# Yorkshire Green Energy Enablement (GREEN) Project

**Document 8.4.5 Applicant's Deadline 2 Response to OFH1 and ISH1  
Hearing Action Points**

**Planning Inspectorate Reference: EN020024**

NATIONAL GRID (YORKSHIRE GREEN ENERGY ENABLEMENT PROJECT) ORDER  
TADCASTER AREA - COMPOSITE PLAN FOR INFORMATION ONLY  
SHEET 1 OF 1

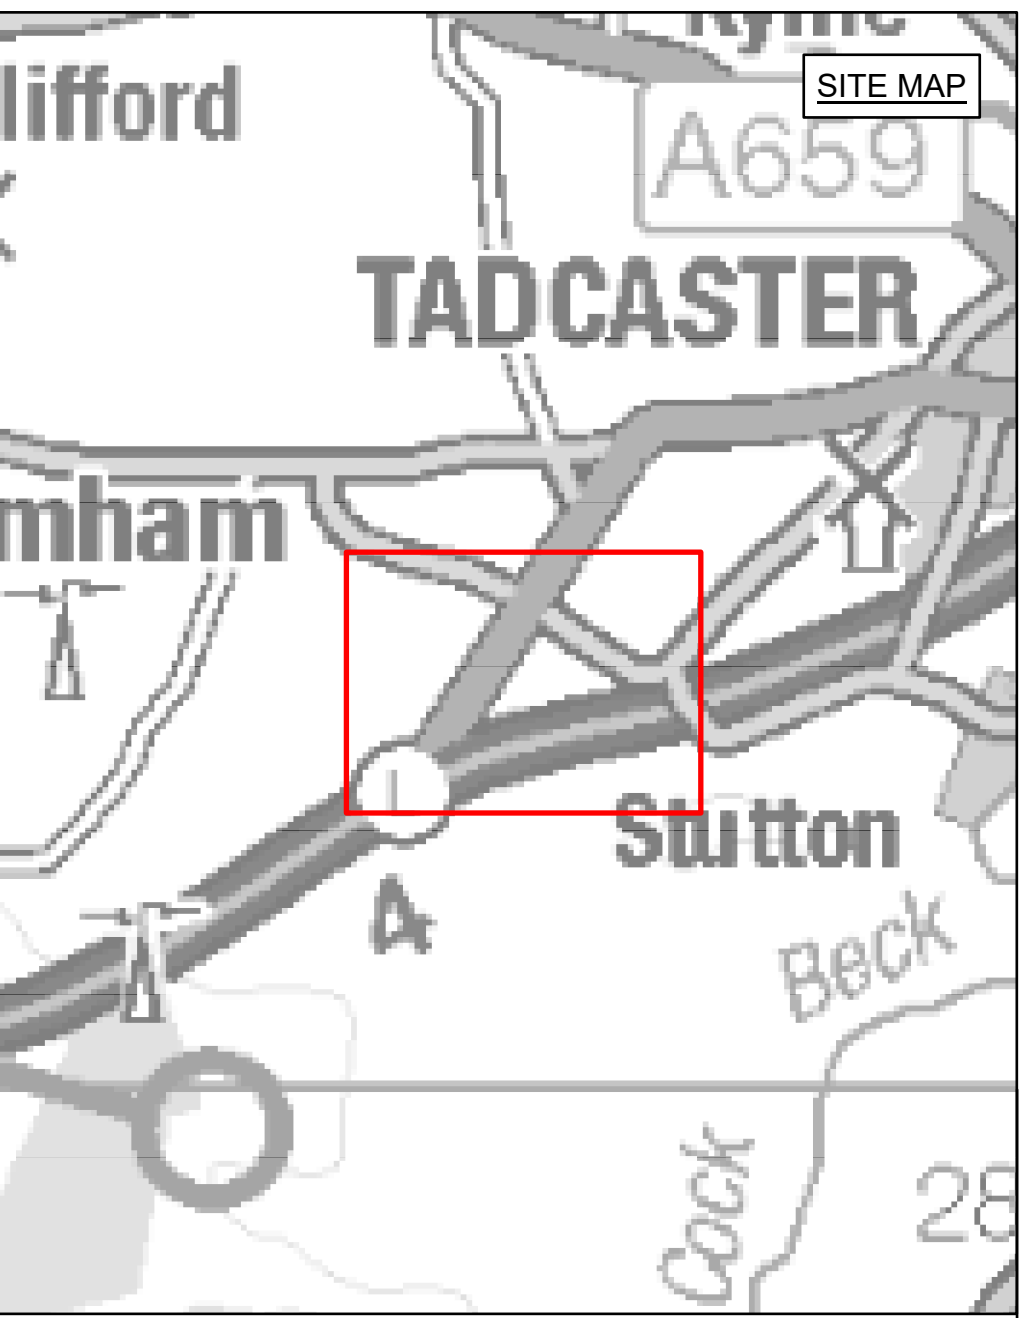
Action No.	ExA description	Party	Deadline	Response
3	Provide a diagram which indicates the Proposed Development which brings together the key information from Access plans, Works plans and Project Description plans for Work No. 8 in the Tadcaster cable sealing end compound (CSEC) area.	The Applicant	D2	<p>National Grid has prepared the requested diagram in relation to the Tadcaster Area which is available to view at <b>Appendix A</b> of this document, which is titled ‘<b>Tadcaster Area – Composite Plan for Information Only</b>’.</p> <p>The plans show different elements of the proposed temporary and permanent construction works in the Tadcaster Area, along with the proposed access points (numbered) and the hedgerow and tree vegetation to be removed.</p>
8	Check that the definition of “maintain” covers all that is required for landscape maintenance.	The Applicant	D3	National Grid is considering the definition of "maintain" and will provide an update on this as requested at Deadline 3.
